Aimee Wilson
Air Permits Section (R6 PD-R)
U.S. EPA Region 6
1445 Ross Avenue, Suite 1200
Dallas, TX 75202
wilson.aimee@epa.gov

RE: Celanese Clear Lake Plant –Permit No. PSD-TX-1296-GHG

A. The Cost Analysis for Carbon Capture and Sequestration In The Region’s Statement of Basis is Invalid

Figure 1

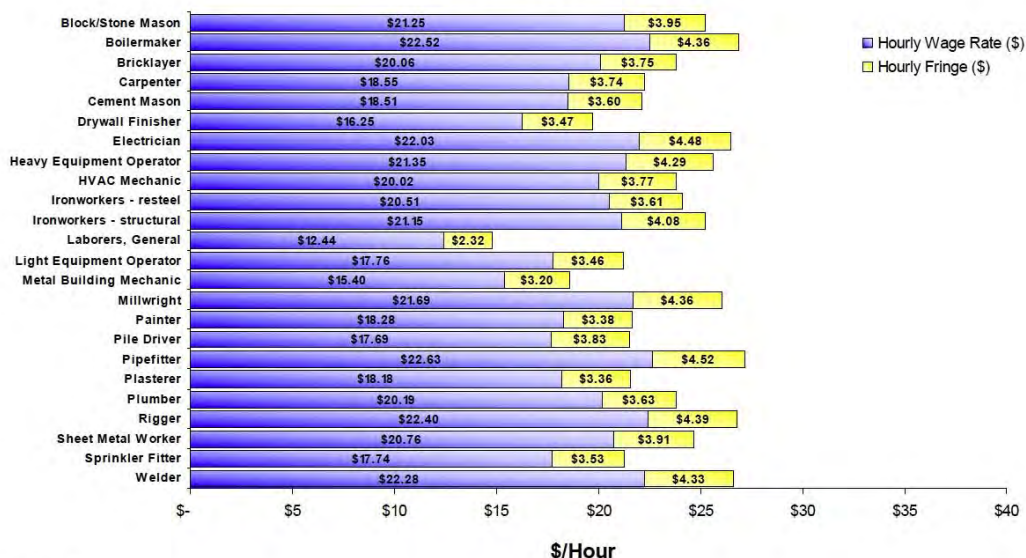
Finally, a 2008 wage survey²⁴ summarizes union and nonunion wages by craft within regions. This survey, reproduced in Figure 1, shows that the highest wage plus benefits in Region 6 (AR, LA, NM, OK, TX) for non-union construction workers is about \$25/hr to \$27/hr for masons, boilermakers, electricians, heavy equipment operators, ironworkers, millwrights, pipefitters, and riggers. None of the skilled craft workers in this survey approach the \$90/hr wage rates assumed in the Worley Parsons analysis. Furthermore, wages have generally fallen since the survey presented in Figure 1.

The \$90/hr wages used in the Worley Parsons analysis are factors of two to three times higher than those reported in the sources reviewed by Sierra Club. The materials the Region

provided for public review contain no support for high labor rates that are an average of \$90/hr for all workers, regardless of skill level.

Sierra Club revised all of the capital equipment costs for the MEA/compression systems, assuming an average fully loaded labor rate of \$40/hr for all crafts, which is at the upper end of the range for the most skilled union workers and thus is still very conservative. (See Exhibit 1, Cells F56 and H56).
